Determination 2017/059

Regarding the refusal to issue a code compliance certificate for a 20-year-old house with mixed claddings at 26 Papaunahi Road, Bowentown

Figure 1: Approximate plan

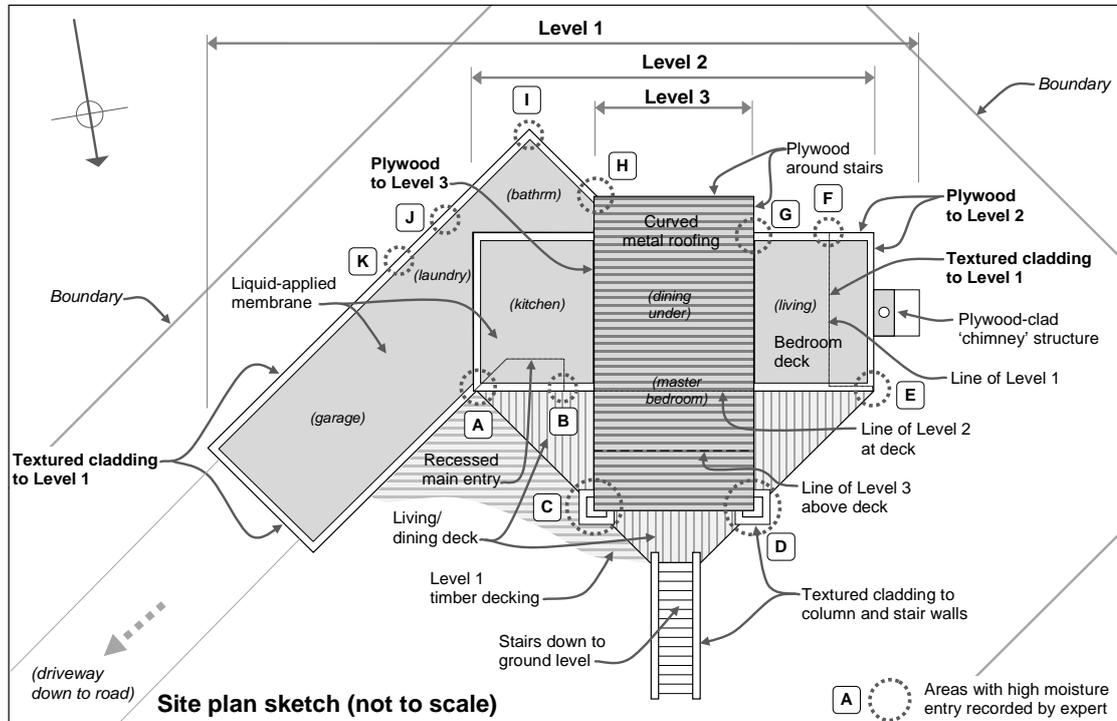
5.3.2 Taking account of the above and of the high risk features, the expert took 17 invasive moisture readings through the textured cladding. The expert recorded the following readings (refer Figure 1 for location of areas shown in brackets):

- over 80% in deck soffit at garage/Level 2 deck junction (Area A)
- 18% in bottom plate at entry recess under wall/deck junction (Area B)
- 27% to over 80% in east column plinth (Area C)
- 36% to over 80% in west column plinth (Area D)
- 48% to over 80% in the northwest wing wall under living area (Area E)
- 20% in bottom plate to the southwest corner to Level 1 bedroom (Area F)
- over 80% in bottom plate at the southwest textured cladding/plywood junction (Area G)
- 38% in bottom plate at the southeast textured cladding/plywood junction (Area H)
- 33% in bottom plate at south corner of bathroom (Area I)

- 23% in bottom plate at laundry door (Area J)
- 25% to 26% at laundry window (Area K).
